SUBJECT: INDIAN POINT NUCLEAR GENERATING UNIT NOS. 2 AND 3 - STAFF  
ASSESSMENT OF INFORMATION PROVIDED PURSUANT TO TITLE 10  
OF THE *CODE OF FEDERAL REGULATIONS* PART 50, SECTION 50.54(f),  
SEISMIC HAZARD REEVALUATIONS FOR RECOMMENDATION 2.1 OF THE  
NEAR-TERM TASK FORCE REVIEW OF INSIGHTS FROM THE FUKUSHIMA  
DAI-ICHI ACCIDENT (TAC NOS. MF3717 AND MF3718)

STAFF ASSESSMENT BY THE OFFICE OF NUCLEAR REACTOR REGULATION

RELATED TO SEISMIC HAZARD AND SCREENING REPORT

INDIAN POINT ENERGY CENTER, UNIT NOS. 2 AND 3

Figure 3.3-1 Plot of Staff's and Licensee's Base Case Shear-Wave Velocity Profiles

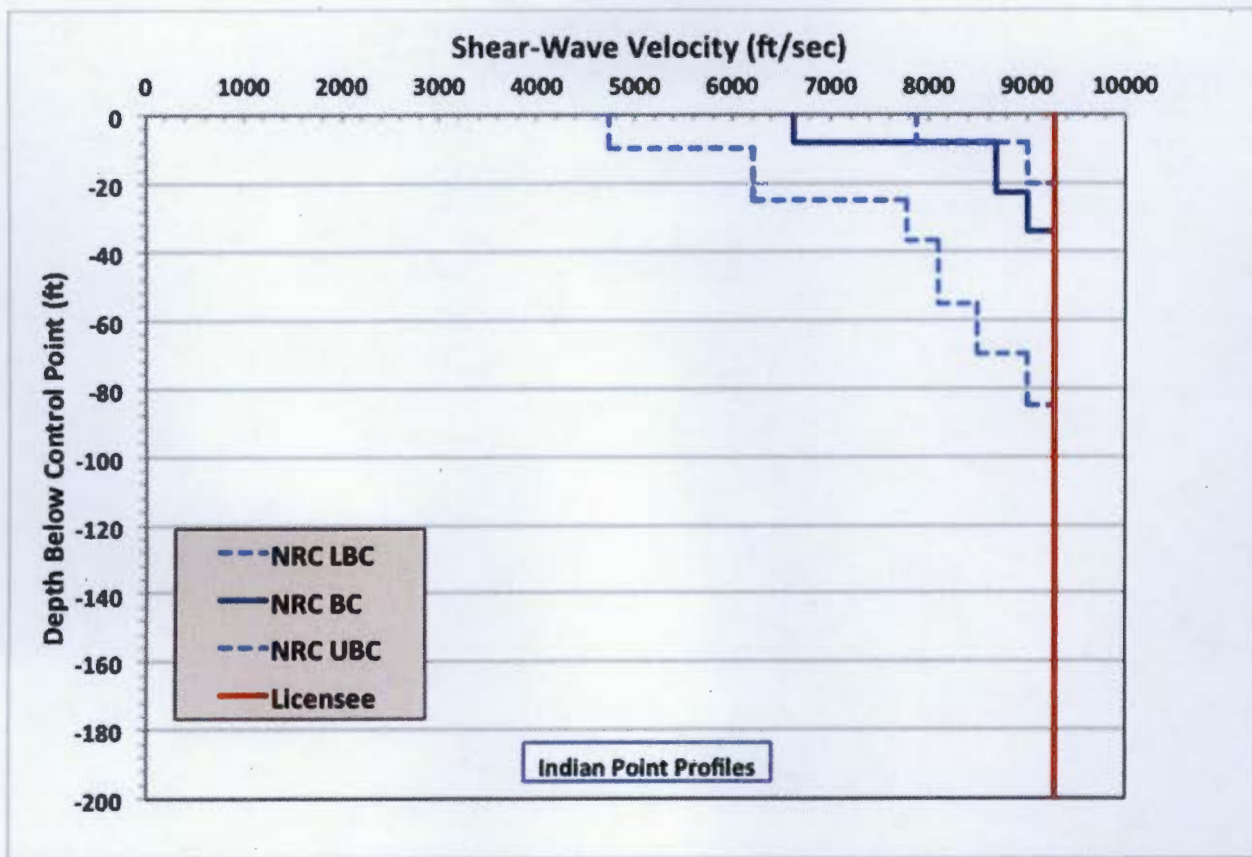
The staff used the information summarized above to develop a range of near-surface firm rock shear velocity estimates for the Indian Point site. As these velocities range from 4,900 to 9,600 ft/sec (1,493 to 2,926 m/sec), the staff developed three base cases with velocity values at the control point of 4,900, 6,800 and 8,400 ft/sec (1494, 2073, and 2561 m/sec) for the lower, best estimate and upper base cases, respectively. The staff then used the SPID template velocity profiles for firm rock site conditions to extrapolate the near surface velocities to depth. Figure 3.3.1 of this assessment shows the three base case velocity profiles developed by the staff.

Figure 3.3-2 Comparison of the Licensee's and NRC Staff's Median Amplification Functions and Uncertainties (Sigma Ln(AF)).

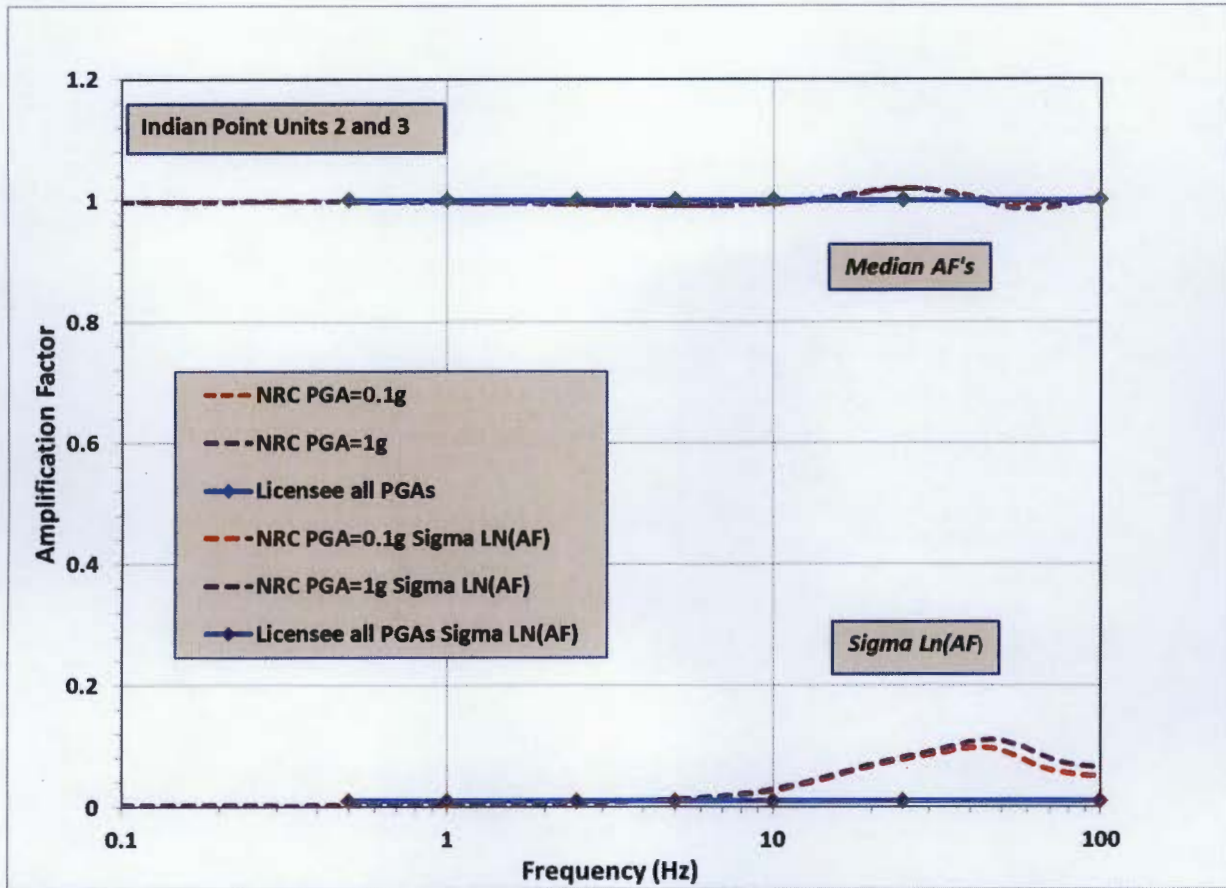
After randomizing each of the three base case profiles and implementing the random vibration theory (RVT) approach to perform the site response calculations, the staff developed site amplification functions. These amplification functions and associated uncertainties for two input loading levels are shown in Figure 3-3.2 of this assessment. The amplification functions produced using the staff's three base case models are very close to unity and the uncertainty is also relatively low, which is consistent with the licensee's determination that a site response analysis for this site is not warranted. Because the licensee did not perform a site response analysis, its amplification function is one and the uncertainty in the amplification function is zero.

Figure 3.3-3 Comparison of NRC Staff's and the Licensee's Mean Control Point Hazard Curves at Selected Frequencies

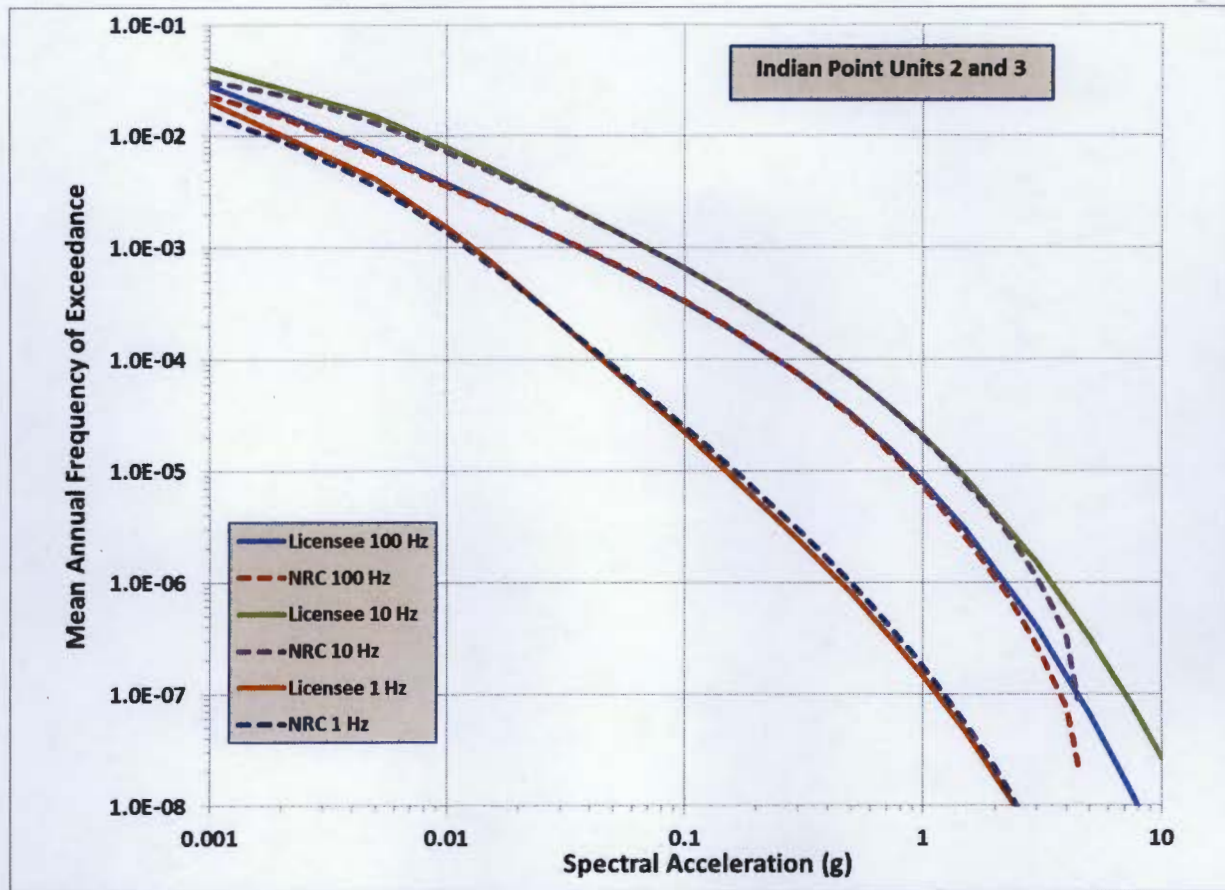
The NRC staff applied Approach 3, as described in Appendix B of the SPID, to compute the probabilistic site-specific control point hazard curves. Figure 3.3-3 of this assessment compares the NRC staff control point hazard curves in comparison to the licensee's hard rock hazard curves, presented in Section 2.3.7 of the SHSR submittal. As shown in Figure 3.3-3, the impact of the staff including the stiff near-surface materials in its site response analyses is generally minimal on the control point seismic hazard curves for mean annual exceedance frequencies greater than  $1 \times 10^{-6}$  per year.

In conclusion, as shown in Figure 3.3-3 of this assessment and discussed below, the staff's site response analysis does not produce significantly different control point seismic hazard curves or the resulting GMRS. Appendix B of the SPID provides guidance for performing site response analyses, including capturing the uncertainty for sites with less subsurface data; however, the guidance is neither entirely prescriptive nor comprehensive. As such, various approaches in performing site response analyses, including the modeling of uncertainty, are acceptable for this application.

Figure 3.4-1 Comparison of the Staff's GMRS with Licensee's GMRS and the Indian Point Unit No. 2 SSE

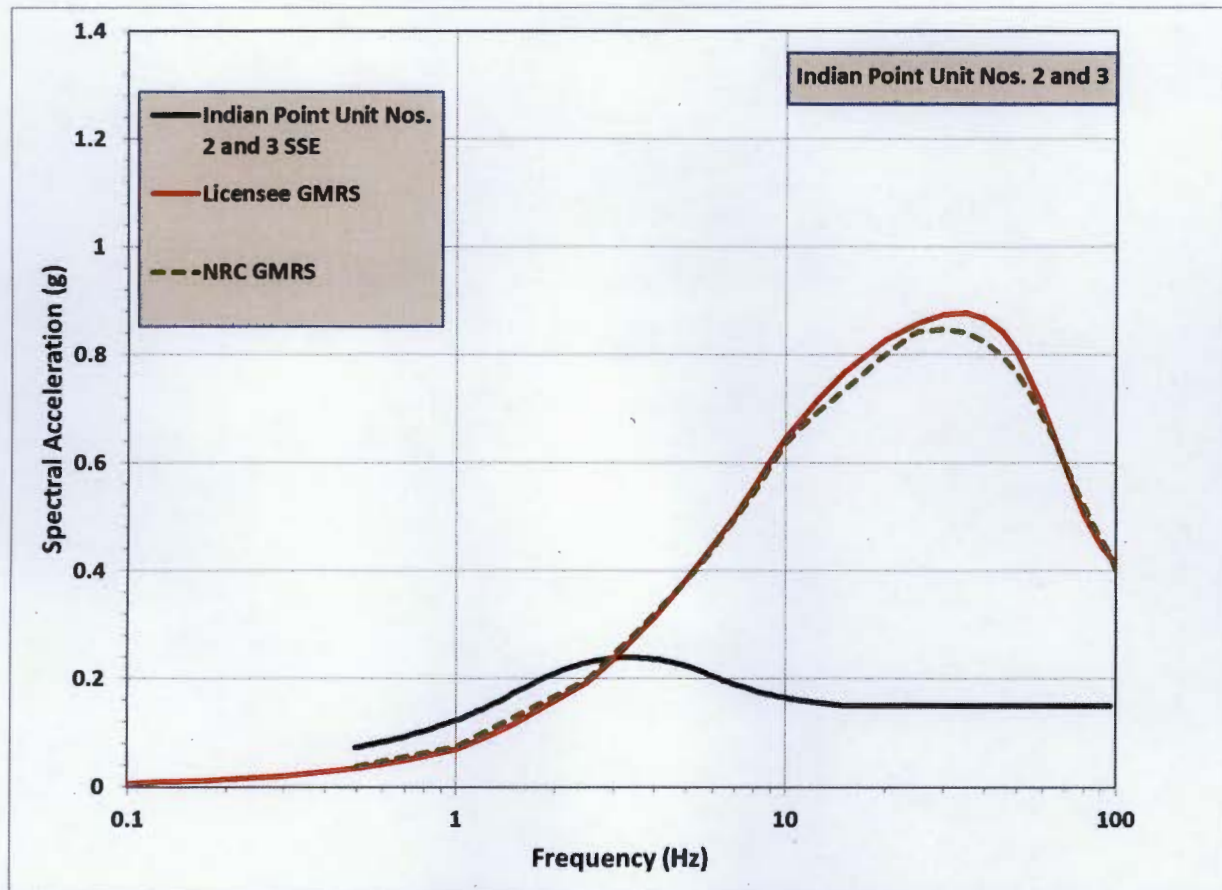
The staff independently calculated the  $10^{-4}$  and  $10^{-5}$  UHRs using the results of its confirmatory PSHA, as described in Sections 3.2 and 3.3 of this staff assessment, respectively. Figure 3.4-1 of this assessment shows a comparison of the GMRS determined by the licensee to that determined by the staff.

As shown in Figure 3.4-1 of this assessment, the staff's GMRS is very similar to the licensee's in both amplitude and shape. Both the licensee's and staff's GMRS exceed the SSE for both Indian Point Units 2 and 3 for all frequencies above 3 Hz. The staff confirms that the licensee used the present-day guidance and methodology outlined in RG 1.208 and the SPID to calculate the horizontal GMRS, as requested in the 50.54(f) letter. The staff performed a PSHA confirmatory
